Informal meeting on Code of Practice for Packing of Cargo Transport Units at the request of the United Nations Economic Commission for Europe Working Party on Intermodal Transport and Logistics

Geneva and virtual, 29-30 March 2023

Comments to changes to clauses 5.3 and 5.2

Submitted by the secretariat

Figure 7.69 - Positioning flexitanks

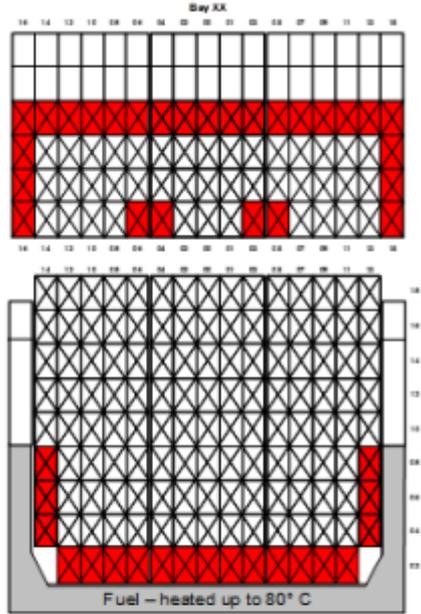
- **Temperature sensitive cargoes⁴ should not be placed on or near heated bunker tanks, the elevated temperature required to keep the fuel viscosity low may heat or otherwise damage the cargo (red slots below deck in figure 7.69).**

- **Above deck, CTUs (containers) with flexitanks should not be stowed in the outer and upper most slots as or at the edges of deck covers (red slots above deck in figure 7.54 as:**
 - **CTUs (containers) in the top slot can be subjected to high temperatures from the sun's radiation.**
 - **CTUs (containers) in the outer slots can be subjected to high acceleration loads.**
 - **CTUs (containers) placed at the edge of the deck covers may have slightly wider separation and there is an increase in the risk of the side walls being bowed outwards.**

“CTUs (containers) in the outer slots can be subjected to high acceleration loads. - CTUs (containers) placed at the edge of the deck covers may have slightly wider separation and there is an increase in the risk of the side walls being bowed outwards”.

It is the principle of the CTU Code that the cargo should be packed in a manner to prevent the CTU and its contents from being damaged when exposed to the acceleration forces expected during transport. It would contradict this principle when specific restrictions have to be observed to limit the acceleration force, such as to avoid sudden braking and change of direction, because the cargo is not capable to withstand the forces normally encountered during transport.

A research carried out by the classification society GL (now DNV) shows the result that a limitation of the contents in a flexitank to maximum 18 tons would ensure that a freight container is not damaged when the acceleration forces which are typical for individual mode of transport are encountered. A paper, summarizing the result of this research, is attached to these comments.

Therefore, it is proposed to limit the maximum net mass of a liquid in a flexitank to 18 tons and to delete the requirement to avoid sudden alterations of direction when transported by road and to delete the requirement to select specific stowage locations providing low acceleration forces when transported by sea.

Alternatively, when such mass limitation is not acceptable to the informal working group, it is proposed not to approve the text in 5.2.8 and not to include this section.
